RE: DA 2020/741/2

19 Edward Street Camden

Division 8.2 Review of Determination for a development involving demolition of existing structures and construction of a two-storey mixed use building with rooftop terrace comprising of 3 commercial premises tenancies and 1 cafe tenancy as well as associated at grade car parking, landscaping and civil works

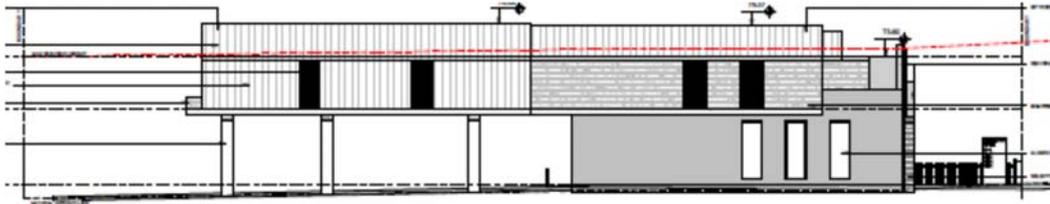
The following diagrams illustrating our points are taken from the architectural plans of JMA as submitted for this 8.2 LPP determination review. As evident in the diagram below, we acknowledge the positive changes of greater rear setback and deletion of the walkway and rooftop terrace.

However, although the rear setback is larger it is not consistent with the rear setbacks of the cottages in the street and in any case is mainly used for parking spaces.

- The green spine and the expected leafiness that is characteristic of the block and of the HCA is largely lost.
- There is little opportunity for landscaping.
- The stilts are entirely uncharacteristic in the HCA. They would not be a consideration if the spirit and letter of the planning instruments and polices were observed, and the cottage was adaptively re-used.

As evident in the above diagram, the design is unsympathetic with its neighbours, and the streetscape. The original dwellings that characterise Edward Street are of single storey, homogenous bulk and scale with a modest and mainly hipped roofscape.

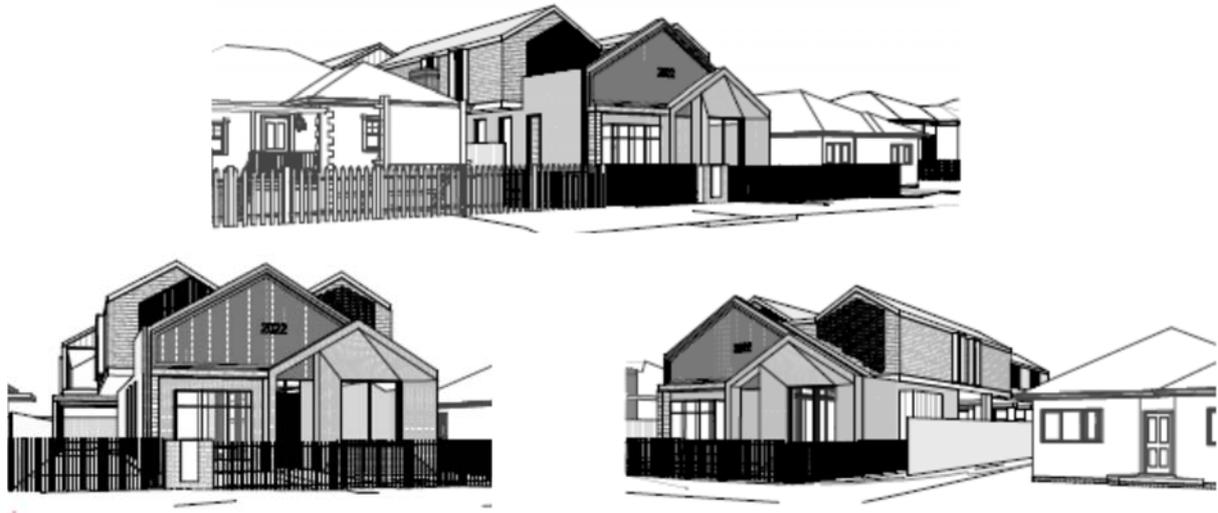
Clearly the height is excessive and dwarfs the cottages. In any case the 7m height limit is breached and is significantly exceeded. This is not acceptable without justification on planning grounds. As the much smaller original cottages are in productive use there are no particular circumstances to argue in relation to the site.

As demonstrated in the above diagrams, the attempt to disguise the bulk and height with a complex of gables is unsuccessful:

- it creates an uncharacteristic almost gothic style roofscape looking from Edward Street;
- the excessive bulk and height are evident from the lateral views;
- the preponderance of gables starkly contrasts with the simple hipped roofscape of the cottages.
